UNITED STATES PATENT AND TRADEMARK OFFICE

10/520,325

Response to Arguments

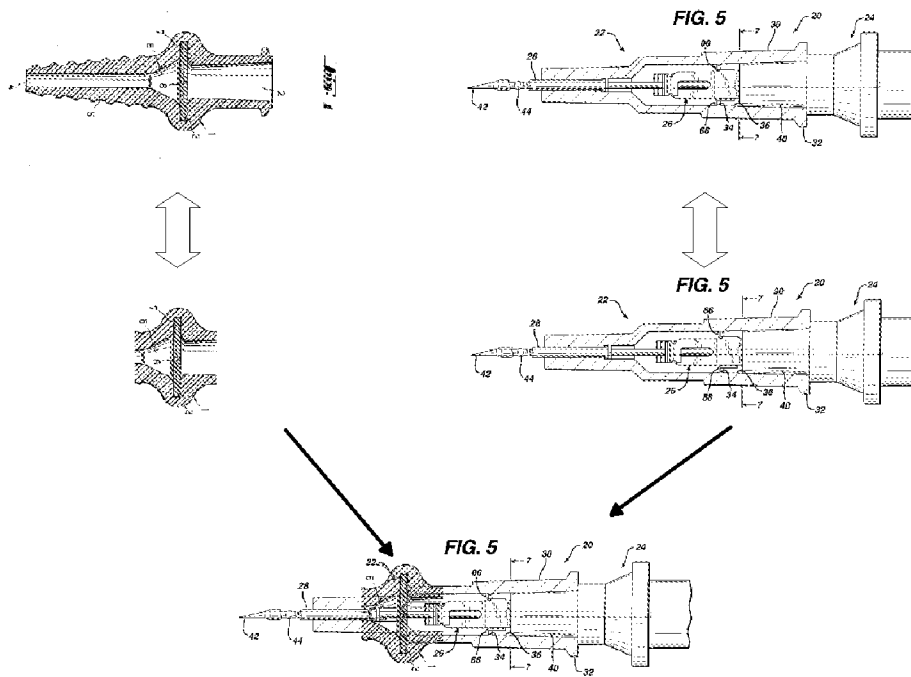
To address applicants' arguments with regards to claim 1, note the Examiners "combo device" (see figures below) is not as depicted by applicants arguments on 6/25/2009 regarding the "combo device" figure on page 13.

With regards to applicants' arguments concerning claims 1, the 103(a) rejections states "....However, *Bialecki* does not disclose wherein a check valve is disposed between the catheter tube and the needle guard element in the catheter hub through which the hollow needle extends in, the ready position and which automatically closes after the removal of the needle, and wherein the check valve remains in the catheter hub when the hollow needle is removed from the catheter hub and the catheter tube. *Tauschinski* discloses (figures 1-4) a check valve (7) for use in the distal end of a catheter hub (1). Therefore it would have been obvious to a person of ordinary skill in the art at the time the invention was made to modify the catheter hub of *Bialecki* (*Bialecki* has space between the guard and the catheter tube as seen in figure 5) as disclosed by *Tauschinski* for providing a **self** sealing valve to block fluid flow.

As for applicants' arguments, the combination of Bialecki and Tauschinski discloses *"wherein a check valve is disposed between the catheter tube and the needle guard element in the catheter hub through which the hollow needle extends in the ready position:"* and *"wherein the check valve remains in the catheter hub when the hollow needle is removed from the catheter hub and the catheter tube"*.

In response to applicant's argument that the combined components of Bialecki (figure 1 above) and Tauschinski (figure 5 above), are not compatible, the fact that applicant has recognized another advantage which would flow naturally from following the suggestion of the prior art cannot be the basis for patentability when the differences would otherwise be obvious. See *Ex parte Obiaya*, 227 USPQ 58, 60 (Bd. Pat. App. & Inter. 1985).

With regards to applicants' arguments concerning claim 6, 15 and 19, and the amended requirement of "two proximally extending legs". It is noted that applicants' specification does not disclose "**legs**" or "two proximally extending **legs**". Therefore, Bialecki (figure 1 above) and Tauschinski (figure 5 above) meets the requirements of the claims as claimed.
